Liaison Communication

Reference: Communication to TIA TR-42 regarding IEEE P802.3at Power via the MDI Enhancements

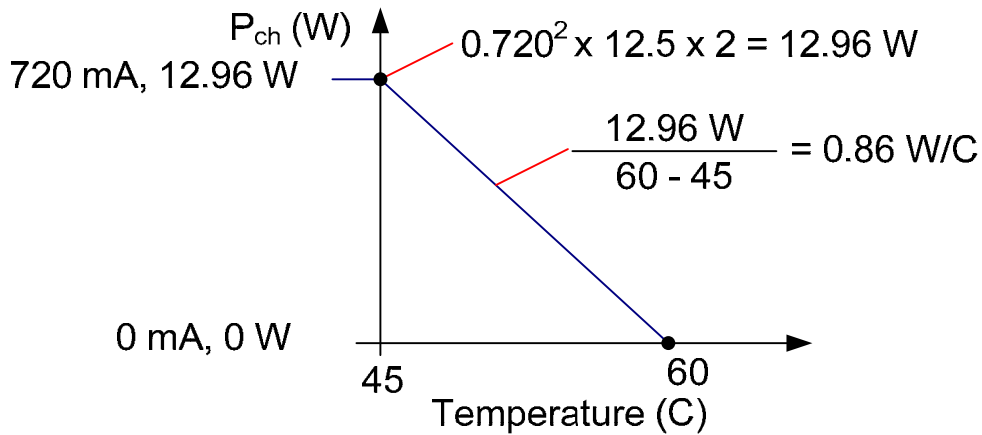
8. Regarding our previous communication to you, the graph that was included (reproduced below) was intended to show the power dissipation in the channel not that of the PD. To that effect, our question is repeated again. Please see the attached graph. Does this graph accurately reflect your de-rating guidance per the technical contribution (Please refer to following link http://www.ieee802.org/3/at/public/jan07/0107_TR42_1.pdf)?

$$P_{ch} = 12.96 - 0.86(T - 45) = I^2 R_2$$
